**From:** "Brenner, Jason (DOT)" <[Jason.Brenner@dot.ny.gov](mailto:Jason.Brenner@dot.ny.gov)>  
**Date:** August 9, 2024 at 3:01:44 PM EDT  
**To:** [planningboard@townofnewburgh.org](mailto:planningboard@townofnewburgh.org)  
**Cc:** Kenneth Wersted <[KWersted@cmellp.com](mailto:KWersted@cmellp.com)>  
**Subject:** SEQR 22-190 Britain Woods Multi-Family

NYS DOT has reviewed the information provide to the state for Britain Woods Multi-Family on Route 207. Please review our below comments and let me know if you have any questions.

**From:** Brenner, Jason (DOT) <Jason.Brenner@dot.ny.gov>  
**Sent:** Friday, November 3, 2023 2:48 PM  
**To:** Brian Dempsey  
**Cc:** Ross Winglovitz; Jane Samuelson; Brian Haggarty; Gorney, Lance (DOT); Zachariah, Siby (DOT)  
**Subject:** RE: Newburgh Britain Woods Preliminary Draft DEIS - NYSDOT SEQR #22-190

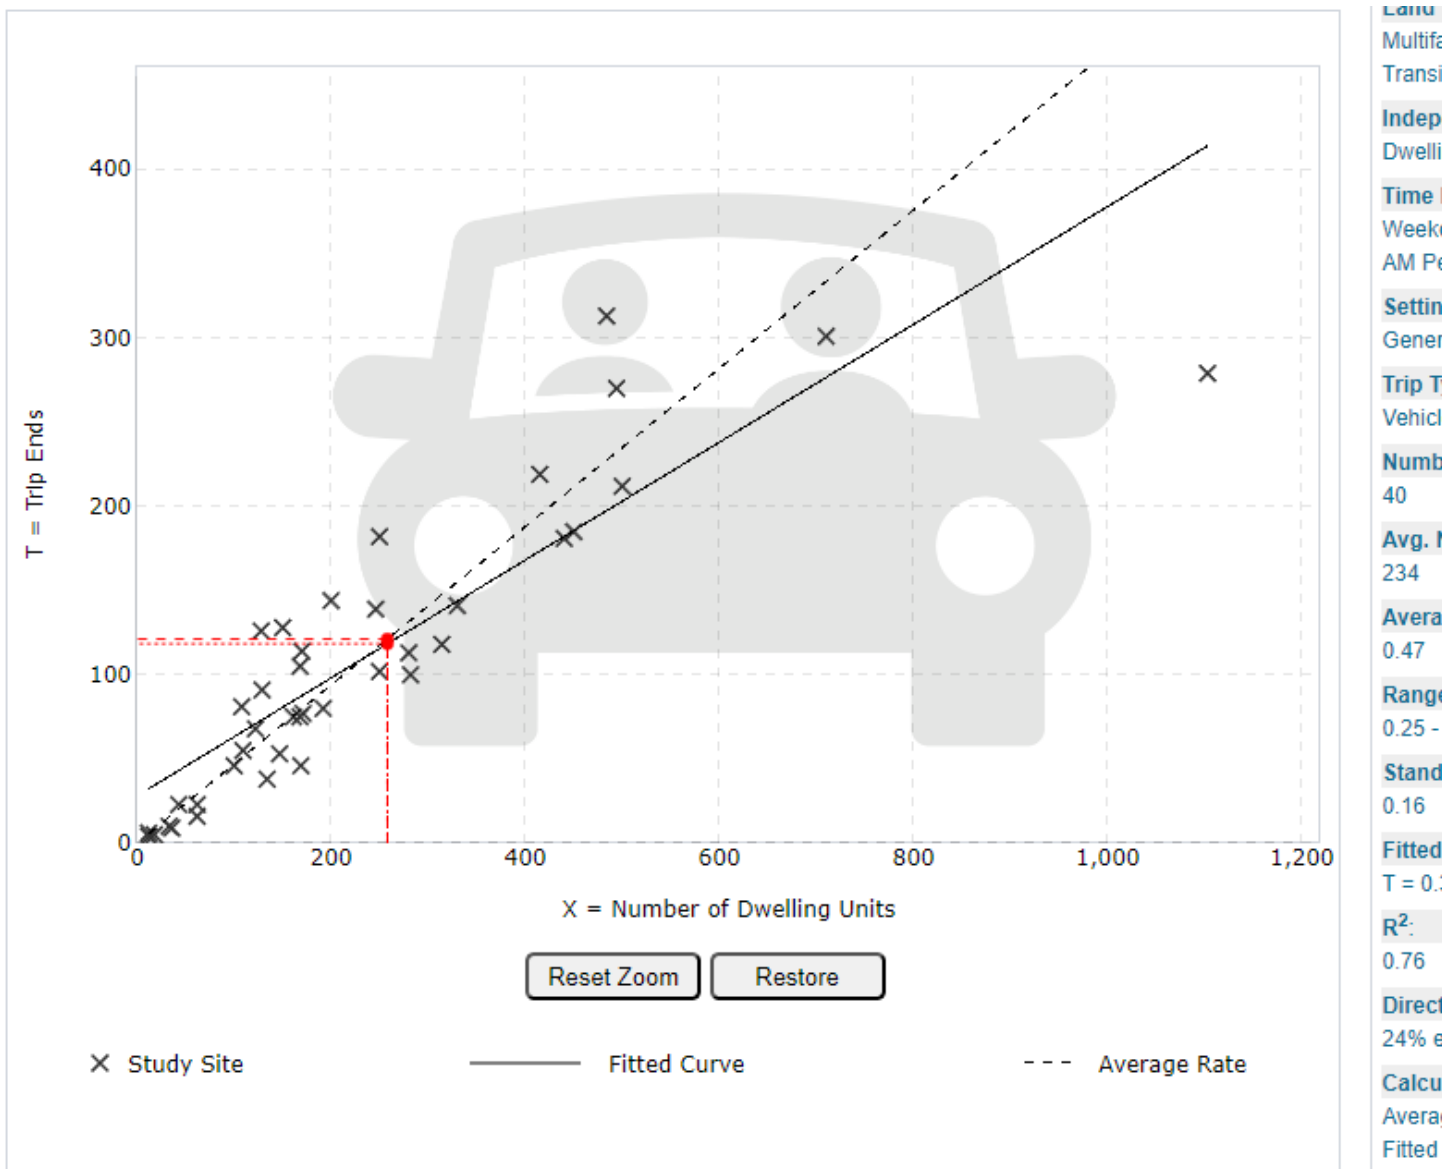
1. Please update the site generate traffic count using Peak Hour ITE trips. The peak hour volumes are higher than the adjacent traffic count used in the TIS and NYSDOT would rather use the higher numbers.
